Informal document No. **GRSG-97-31**
(97th GRSG, 20 – 23 October 2009
agenda item 13)

Proposal for draft amendments to the Regulation on Driver's Forward Field of Vision (ECE 125)

Analysis of the current regulation ECE 125 in the case of a steering wheel below the 4° plan

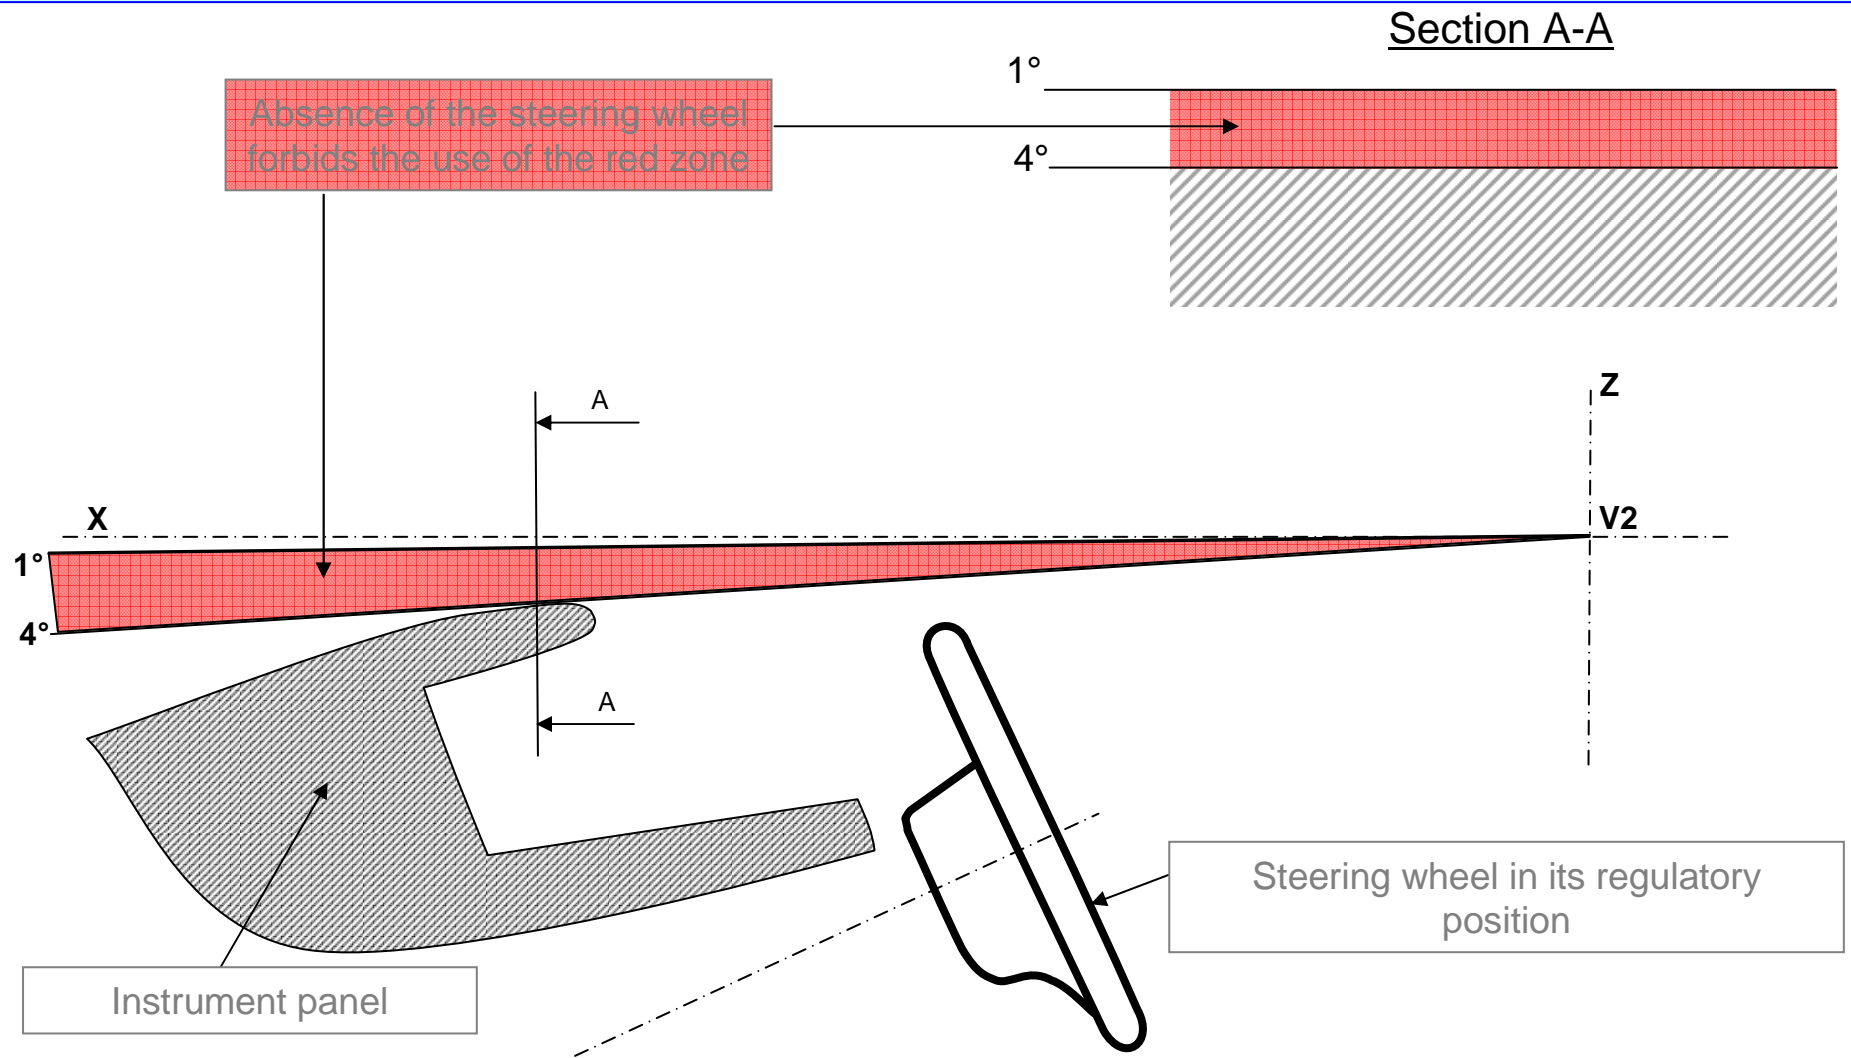
Below to 4°, there is no relationship between the steering wheel position and the instrument panel

Proposed amendment to regulation ECE 125

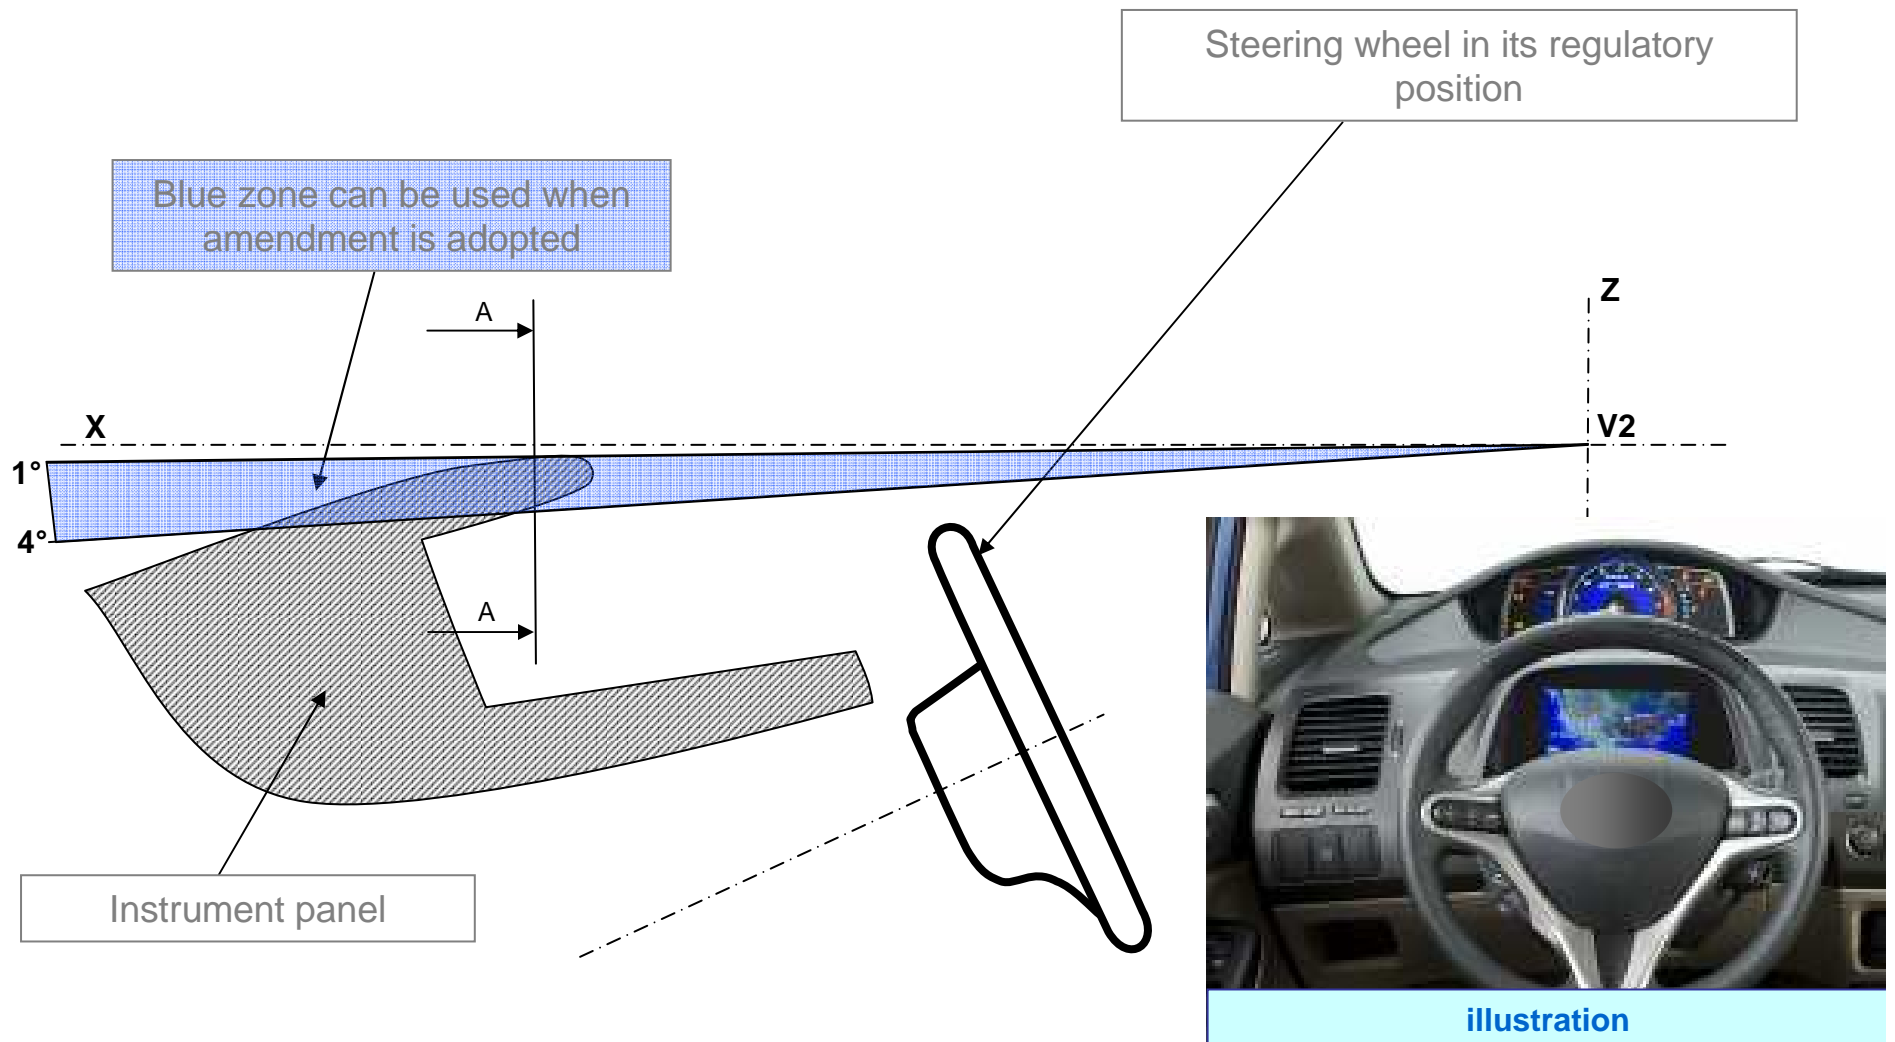
- ➔ Proposal : De-activating the relationship between the steering wheel position and the instrument panel between the 1° and 4° planes
